Babylon Garments & Dresses LTD

30 March 2014

Building Observations

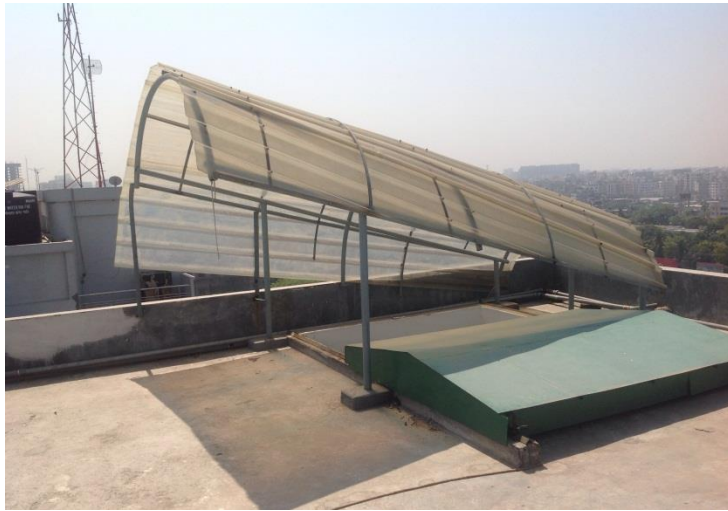
**Stability of steel roof to dining area to
be reviewed by Building Engineer**

Building Engineer to confirm support/connection detail at these locations.

Roof structure to Dining Area not shown on the structural design drawings, no bracing visible, may be susceptible to wind uplift. Building Engineer to review.

5	No bracing observed in steel roof structure. Stability of steel roof to Dining Area to be reviewed by Building Engineer to confirm that it is braced and adequately designed to resist high wind loading	The steel roof over the Dining Area should be reviewed by the Building Engineer and, if required, upgraded to support code vertical and wind loads or the area should be vacated and removed.	6-weeks

Possible falling objects

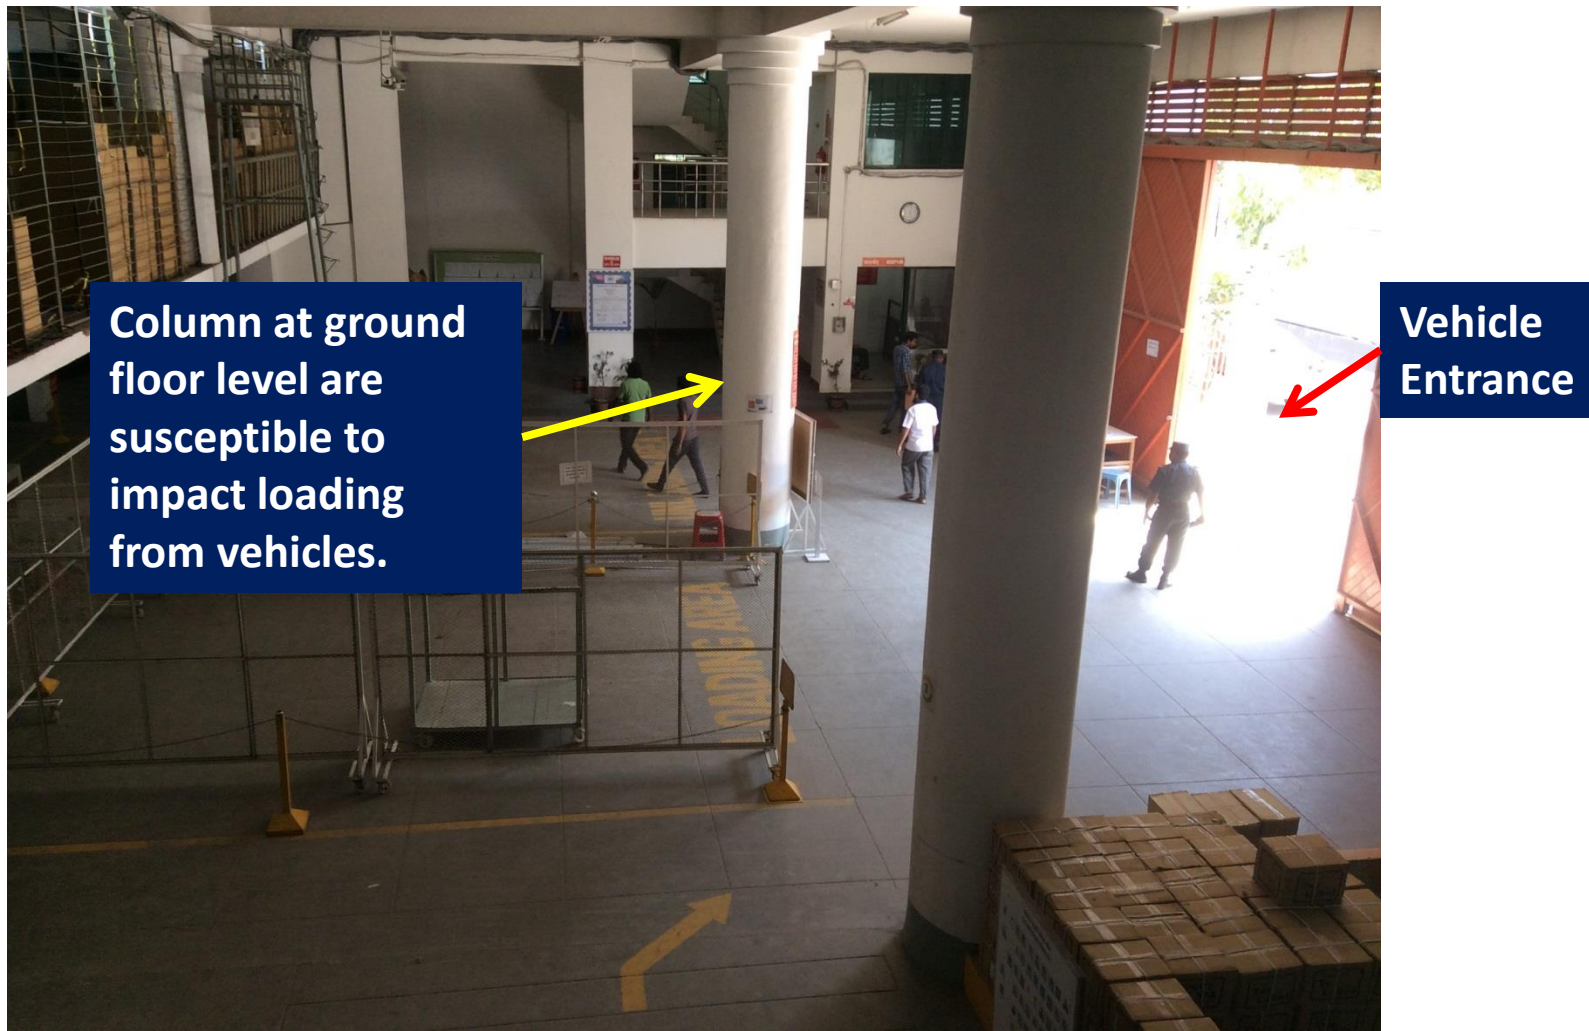
Falling hazards
Stairwell canopies, Mast and
Column/Beam at roof level.

**Stairwell canopy construction very light,
may be susceptible to wind uplift.
Building Engineer to review.**

**Stability of mast unknown.
Building Engineer to review.**

Item No.	Observation	Recommended Action Plan	Recommended Timeline
6	Falling hazards – stairwell canopies, mast at roof level.	Lightweight canopies over stair-cores access to roofs to be strengthened or removed	6-weeks
7	Falling hazards – stairwell canopies, mast at roof level.	The connection of the mast to the roof structure is to be assessed by the building engineer for stability.	6-weeks
8	Falling hazards – stairwell canopies, mast at roof level.	Building Engineer to review all of the above and provide calculations and drawings demonstrating the adequacy of the structure/connections and /or evidence of how the structures are made safe	6-weeks
9	Columns at ground floor level are susceptible to impact loading from vehicles	Column to be protected from vehicle impact.	6-weeks
10	Cantilevered Window Cills/Brick Infill	Building Engineer to monitor these elements of the structure for signs of further cracking/movement and take preventative action if necessary.	6-months
